MEMORANDUM

Subject: 34002 Mershon Road, Oregon - Drainage Facility Relocation

SITE PLAN: NORTHWEST CORNER

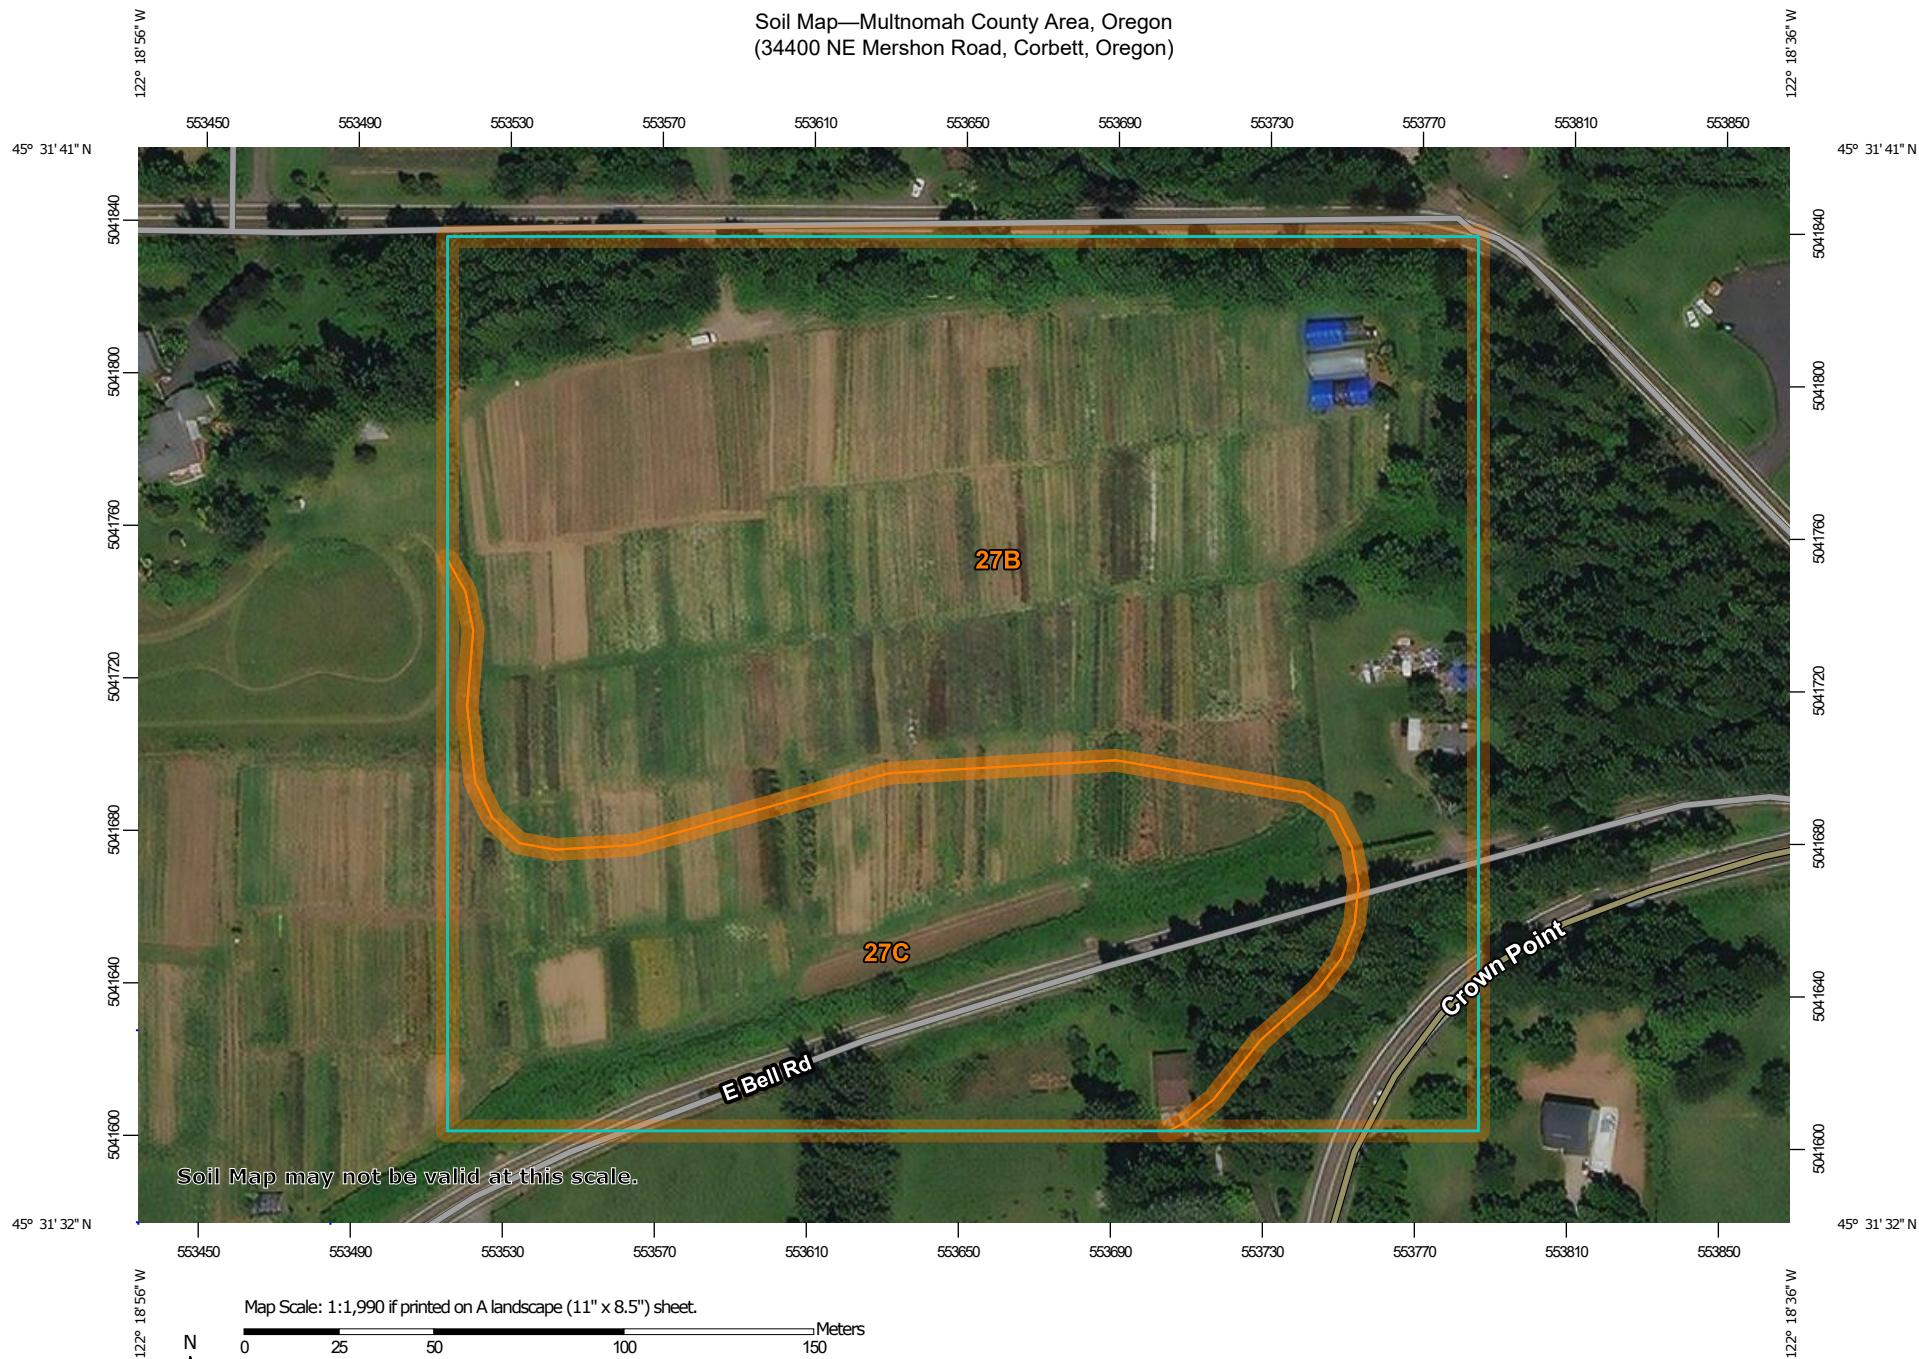
In its review of the proposed onsite sanitary facilities, the City of Portland indicated a potential conflict between the proposed stormwater infiltration facility and the proposed sanitary drain field and replacement drain field. The conflict can be eliminated by moving the stormwater infiltration facility 70 feet south to a location that places it down slope from the sanitary drain field a distance of 50 feet and upslope from the replacement drain field a distance of 50 feet. The stormwater infiltration facility will have a 10-foot setback from the property line. See the attached site map to view the revised layout.

With this memorandum, Ecological Engineering modifies the design of the stormwater infiltration facility to a location that is 70 feet south of the location currently shown on the plans, with a 10-foot setback from the property line to the west. The soils in both locations are Mershon Silt Loam. I certify that, due to the fact that the soils and soil characteristics in the proposed new location for the facility are the same as those soils and characteristics in the originally presented location, all facility design and sizing remains valid. The NRCS Soil Survey map and legend for the site is attached for reference.
